Product Change Notification / RMES-21XLMM744

CCB 6131 Final Notice: Implement top marking changes for selected PSDS (Power Switching Discrete Solutions) Silicon Carbide (SiC) Products available in TO-247, TO-263, TO-268, TO-220 and SOT-227 packages.

CCB 6131
Pre and Post Change Summary
PCN #: RMES-21XLMM744

TOP MARKING CHANGE (TO-247)

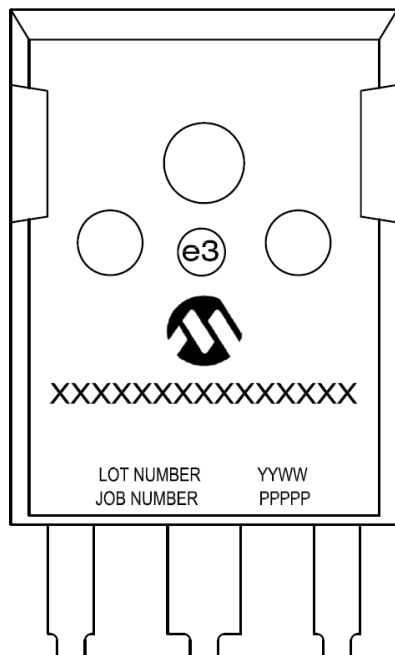
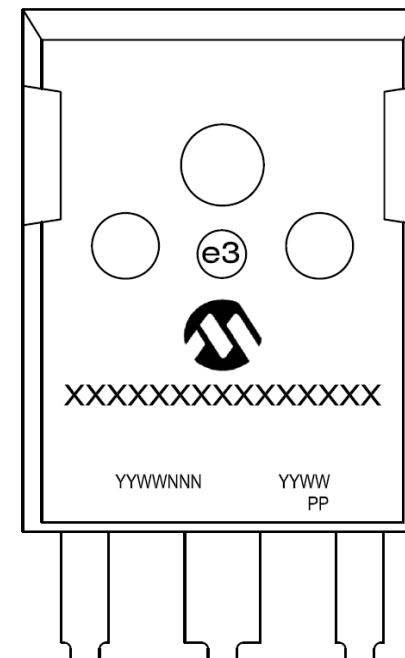
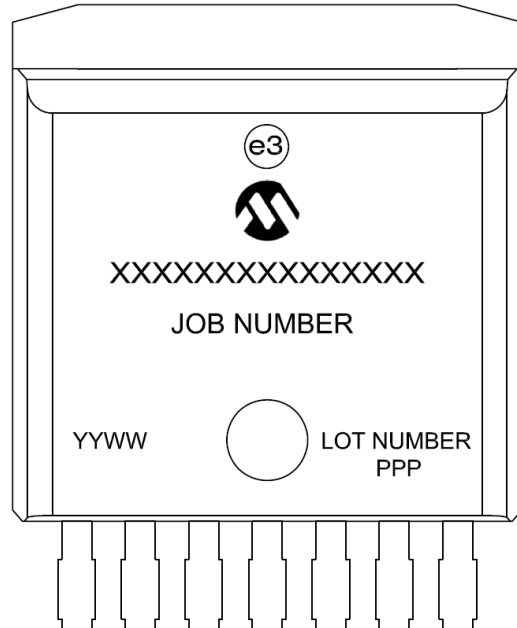
Pre Change

XXX = Finished Goods Part Number

PPP = Country of Origin (PHIL-F or PHILIPPINES)

Lot Number = Fab Lot

Job Number = Internal tracking #

Date Code = YYWW

Post Change

XXX = Finished Goods Part Number

PP = Country of Origin (ISO Alpha-2 digit)

Trace Code = YYWWNNN

Date Code = YYWW

TOP MARKING CHANGE (TO-263)

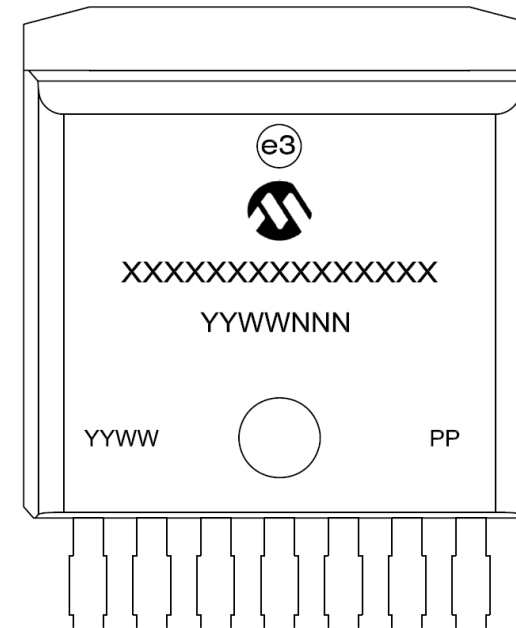
Pre Change

RoHS Symbol (e3)
XXX = Finished Goods Part Number
PPP = Country of Origin (PHIL-F or PHILIPPINES)
Lot Number = Fab Lot
Job Number = Internal tracking #
Date Code = YYWW

Post Change

RoHS Symbol (e3)
XXX = Finished Goods Part Number
PP = Country of Origin (ISO Alpha-2 digit)
Trace Code = YYWWNNN
Date Code = YYWW

TOP MARKING CHANGE (TO-268)

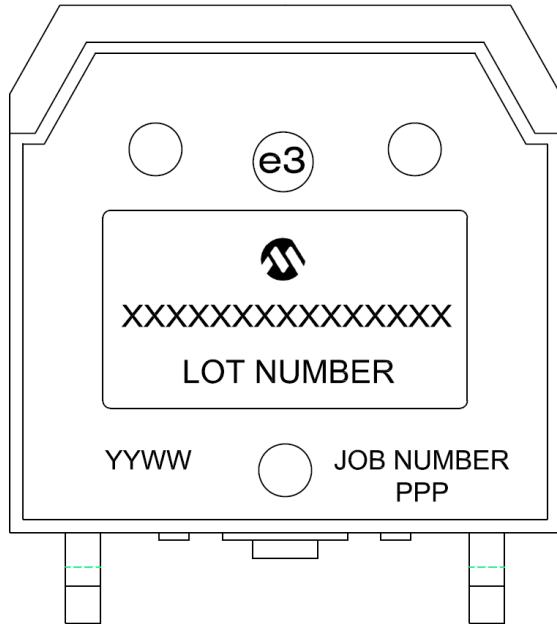
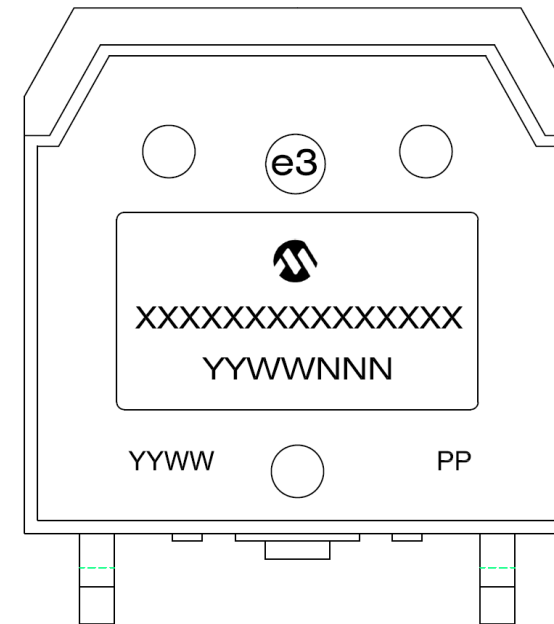
Pre Change

RoHS Symbol (e3)
XXX = Finished Goods Part Number
PPP = Country of Origin (PHIL-F or PHILIPPINES)
Lot Number = Fab Lot
Job Number = Internal tracking #
Date Code = YYWW

Post Change

RoHS Symbol (e3)
XXX = Finished Goods Part Number
PP = Country of Origin (ISO Alpha-2 digit)
Trace Code = YYWWNNN
Date Code = YYWW

TOP MARKING CHANGE (TO-220)

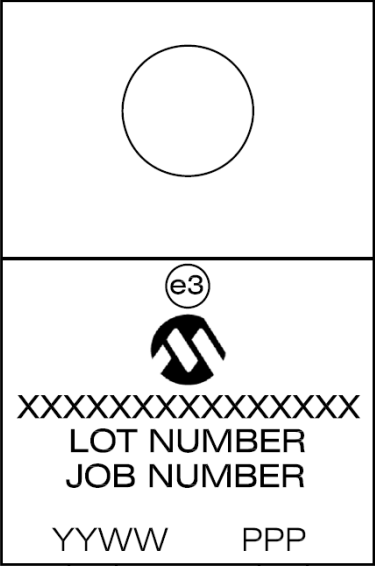
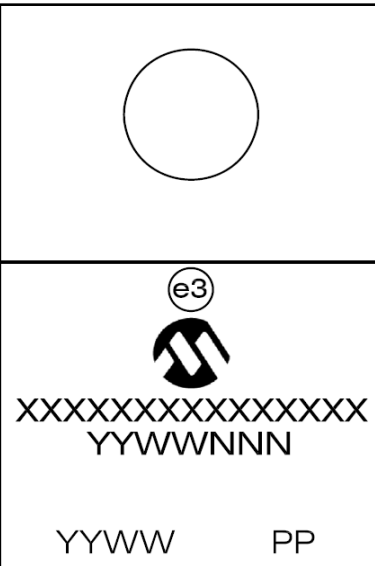
Pre Change	Post Change
 <p data-bbox="259 976 1177 1305">RoHS Symbol (e3) XXX = Finished Goods Part Number PPP = Country of Origin (PHIL-F or PHILIPPINES) Lot Number = Fab Lot Job Number = Internal tracking # Date Code = YYWW</p>	 <p data-bbox="1452 1005 2247 1276">RoHS Symbol (e3) XXX = Finished Goods Part Number PP = Country of Origin (ISO Alpha-2 digit) Trace Code = YYWWNNN Date Code = YYWW</p>
